ADDENDUM #3

RE: **CP121908 – LASP/Tenant Finish**
BURKETTDESIGN Project Number: 10042.000

The following is in response to the consolidated comments received from David Lindblad on or before June 24, 2011.

PROJECT: University of Colorado at Boulder, LASP
CP-121908

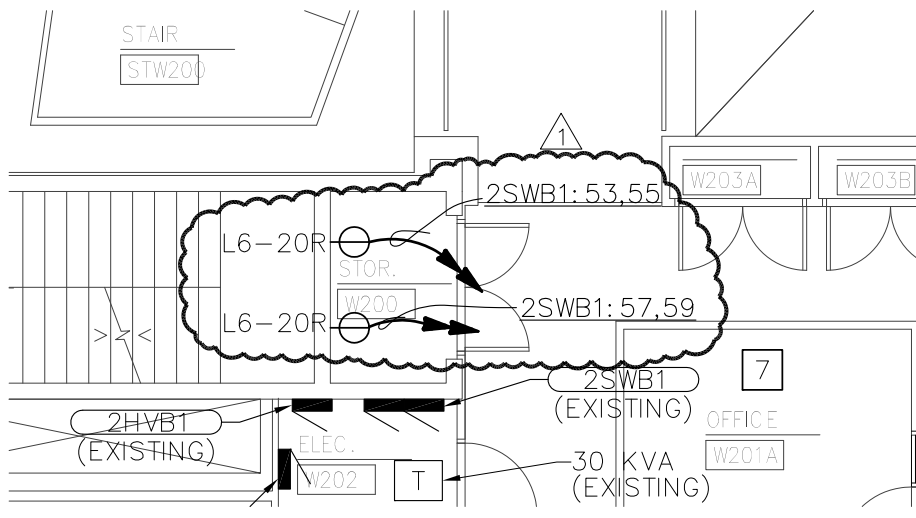
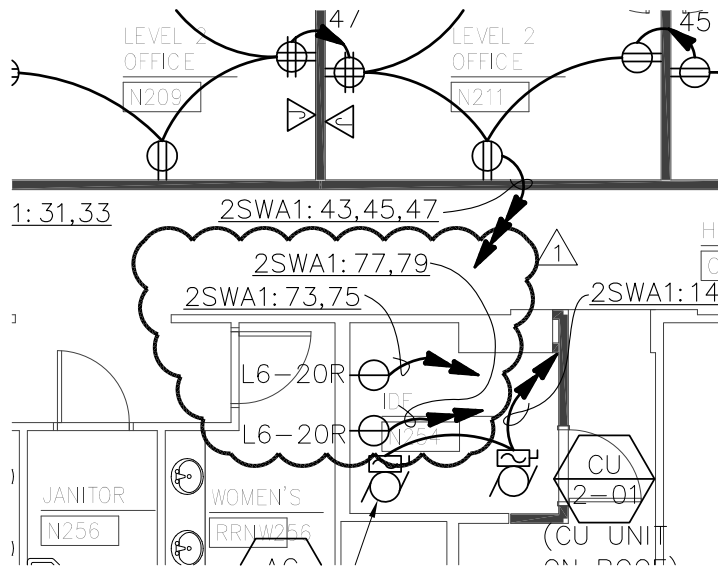
- 06 **Question:** T2.01 - Polycomm needs to be hired for the wireless so as past projects you should add holding jacks on the prints however hopefully this review is complete and nailed down for the CD phase.

1. This hasn't been confirmed and I don't see any WAP holding outlets. Comment on June 1, 2011.
- Rimrock**
- Response:** **This survey has not been completed by Accuvant. We will provide a narrative for Addendum #3 for bidding purposes.**

- Rimrock**
- Response:** **This is not typically performed by the low-voltage contractor.**
- 09 **Question:** T2.02 - Polycomm needs to be hired for the wireless so as past projects you should add holding jacks on the prints however hopefully this review is complete and nailed down for the CD phase.

1. This hasn't been confirmed and I don't see any WAP holding outlets. Comment on June 1, 2011.
- Rimrock**
- Response:** **This survey has not been completed by Accuvant. We will provide a narrative for Addendum #3 for bidding purposes.**

1. Provide eighty-eight (88) wireless access point package throughout the 1st and 2nd floors, each consisting of one Category 6 cable, one WAP enclosure, and one Wireless Access Unit, per Specifications, including all incidental materials, to provide a complete wireless access point ready for the Owner's use.

2: Provide add/delete unit cost for one (1) wireless access point package, each consisting of one Category 6 cable, one WAP enclosure, and one Wireless Access Unit, per Specifications, including all incidental materials, to provide a complete wireless access point ready for the Owner's use.

SKETCH NO.: **SKE-01**

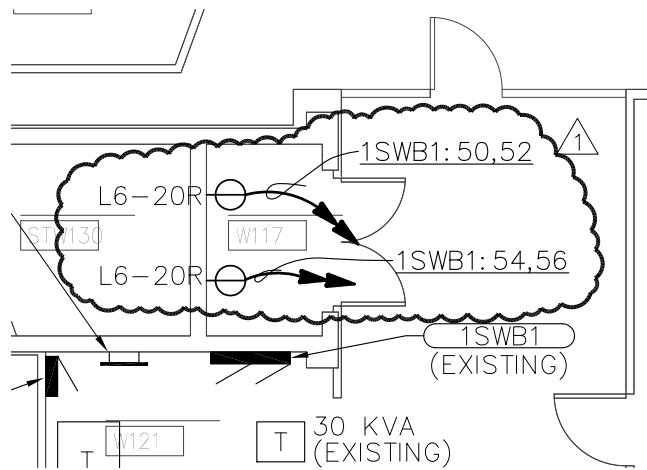
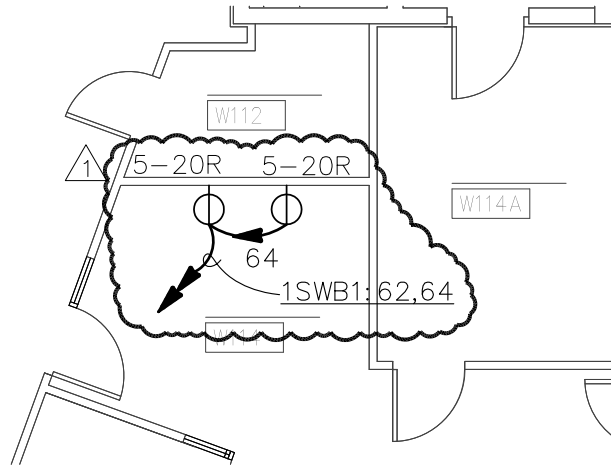
18 Question: T3.04 - For the IDF W200 Room Plan, add a dedicated power outlet per Jane Folger's direction.

8. I don't see that this has been addressed. Comment on June 1, 2011.

Rimrock **Response:** **This will be coordinated in the field. There is not enough room for cable runway to surround the room and have (2) routes for cabling.**
21 **Question:** T3.03 - For the IDF N254 Room Plan, add a dedicated power outlet per Jane Folger's direction.

11. I don't see that this has been addressed. Comment on June 1, 2011.

Rimrock Response: This has been coordinated will be on the electrical drawings.

Refer to SKE-01 & SKE-04 dated 06.27.11

Rimrock **Response:** **This has been coordinated will be on the electrical drawings.**

Refer to SKE-01 & SKE-03 dated 06.27.11
